Title-Sujet <b>Administration heating and hot water upgrade/ Kejimikujik national Park</b>		Date <b>2017.12.14</b>
Solicitation No. - No. de l'invitation <b>5P201-17-5132/A</b>		Client Ref. No. - No. de réf du client.
GETS Reference No. - No de reference de SEAG		
Solicitation Closes L'invitation prend fin –  <b>at – à 2:00 PM on – le 2017-12-19</b>		Time Zone Fuseau horaire - <b>EASTERN STANDARD TIME (EST)</b>
F.O.B. - F.A.B. Plant-Usine: <input type="checkbox"/> Destination: <input type="checkbox"/> Other-Autre: <input type="checkbox"/>		
Address Inquiries to: - Adresser toute demande de renseignements à :  Sylvie Lagacé <a href="mailto:sylvie.lagace@pc.qc.ca">sylvie.lagace@pc.qc.ca</a>		
Telephone No. - No de téléphone <b>418-648-5006</b>		Fax No. - No de FAX: <b>418-649-6971</b>
Destination of Goods, Services, and Construction: Destinations des biens, services et construction:  <b>See Herein</b>

## AMENDMENT #4

THE PURPOSE OF THIS AMENDMENT IS TO PROVIDE UPDATES TO THE DRAWINGS AND SPECIFICATIONS AND TO ANSWER QUESTIONS RECEIVED BY POTENTIAL BIDDERS.

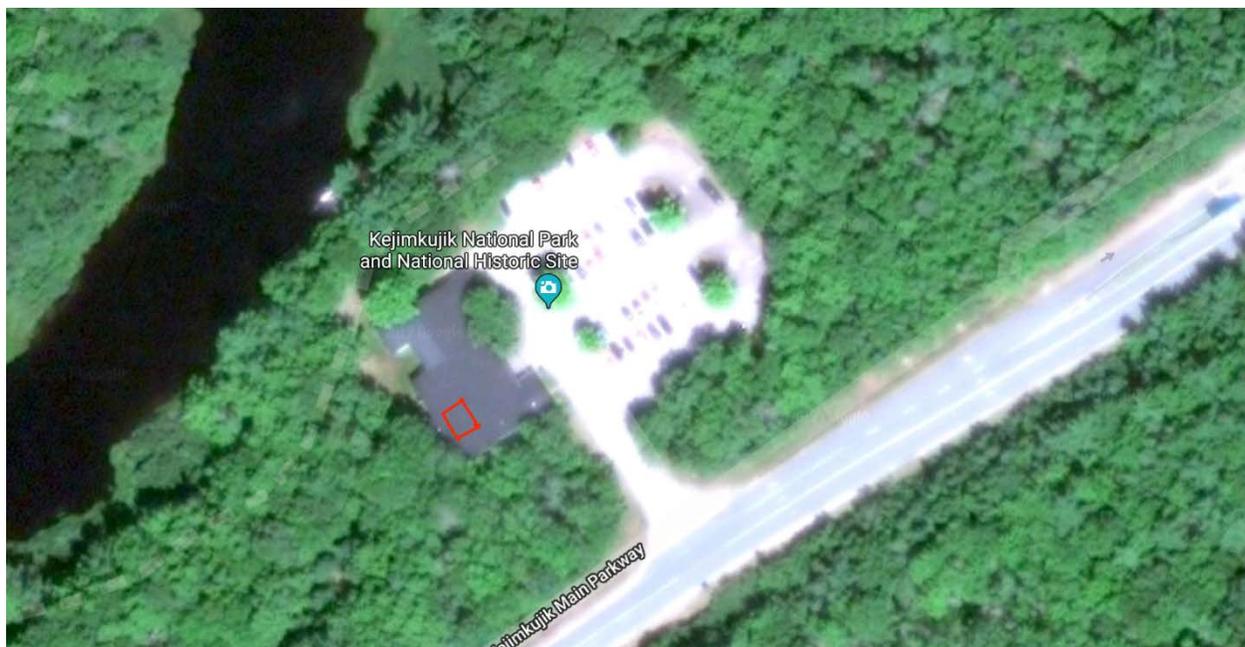
Q2. Location that solar panels are to be installed.

R2. Solar to be installed on the SSW portion of the roof (i.e. back left corner if you are look at the front of the building from the parking lot). Install should consider the tree line on the left hand side of the building, and push right as far as it needs to be to avoid shading. I've attached a picture from Google Maps for quick reference.
